**Title: Hwy 2A & Dunbow Rd. Intersection–Improvement & Signalization**

Memorandum (or Approval) Date: February 9<sup>th</sup>, 2015

Design Exception Request Date: January 23<sup>rd</sup>, 2015

Approval Status: Approved

Dunbow Road Re-alignment with Intersection Angle at 67 degrees

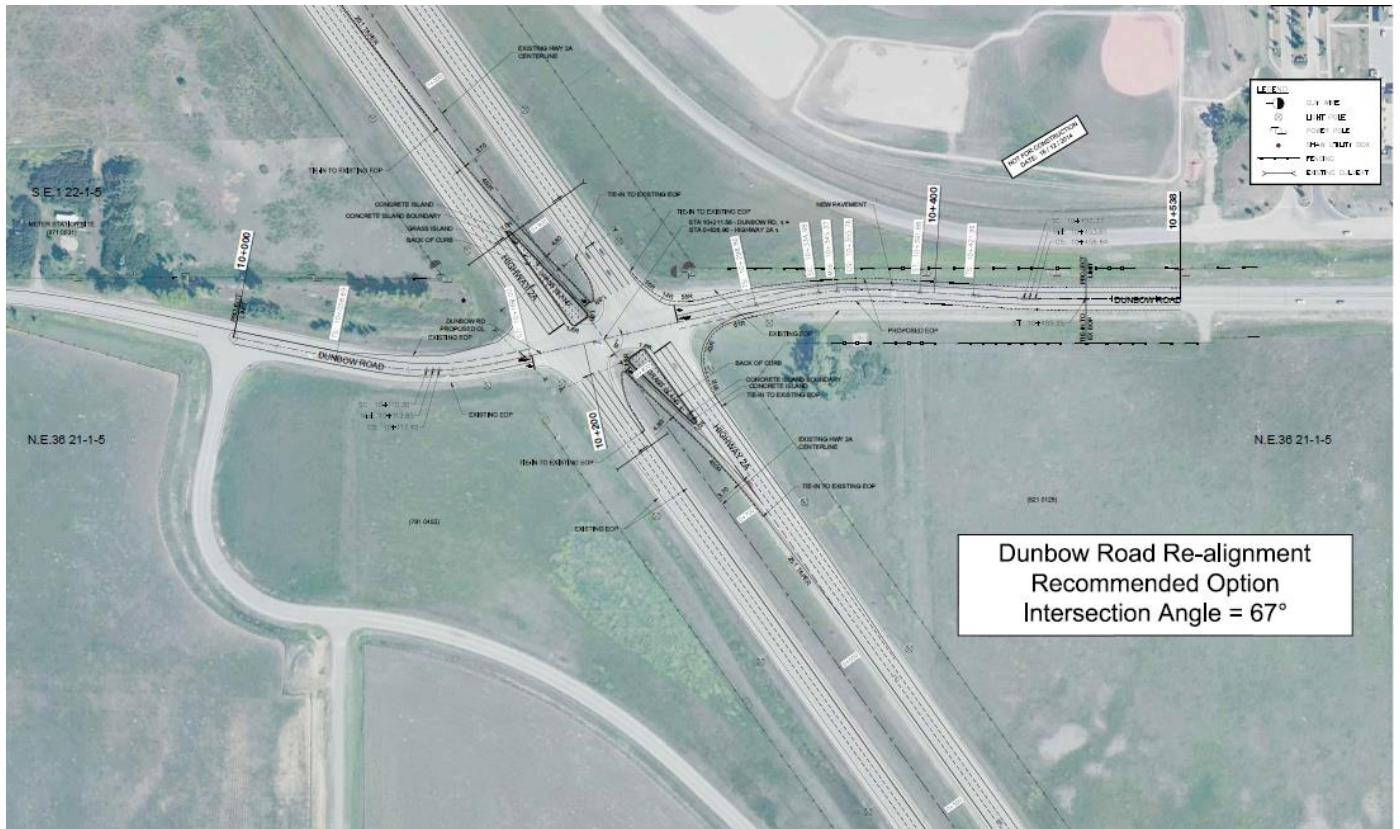
| Summary   |
|---|
| <p>The existing skew angle of 70 degrees does not provide sufficient tangent section to ensure that the through movement along Dunbow Road (eastbound – westbound movement) is aligned. The re-aligned skew angle will be at 67 degrees.</p> <p>In addition to the re-alignment of Dunbow Road, the intersection is proposed to be signalized with adequate illumination. The posted speed approaching the intersection from the North/South will be 80 km/h and the posted speed approaching the intersection from the East/West will be 50km/h.</p> |

| Rationale for Approval/Rejection  |
|---|
| <ul style="list-style-type: none"> <li>• The skew angle will be 67 degrees which provides an aligned East/West movement</li> <li>• Provides the most cost effective option among the several reviewed</li> <li>• This option provides less throwaway of the existing pavement and also accommodates future growth</li> <li>• A reduced skew angle will negatively impact the sightlines for a vehicle approaching the intersection on Dunbow Road. The risk is mitigated by the signalization of the intersection</li> <li>• A relatively flat vertical alignment exists along Highway 2A and Dunbow Road with the intersection on a tangent section on Highway 2A</li> <li>• Adequate illumination approaching the intersection and proper signage will be provided</li> </ul> |
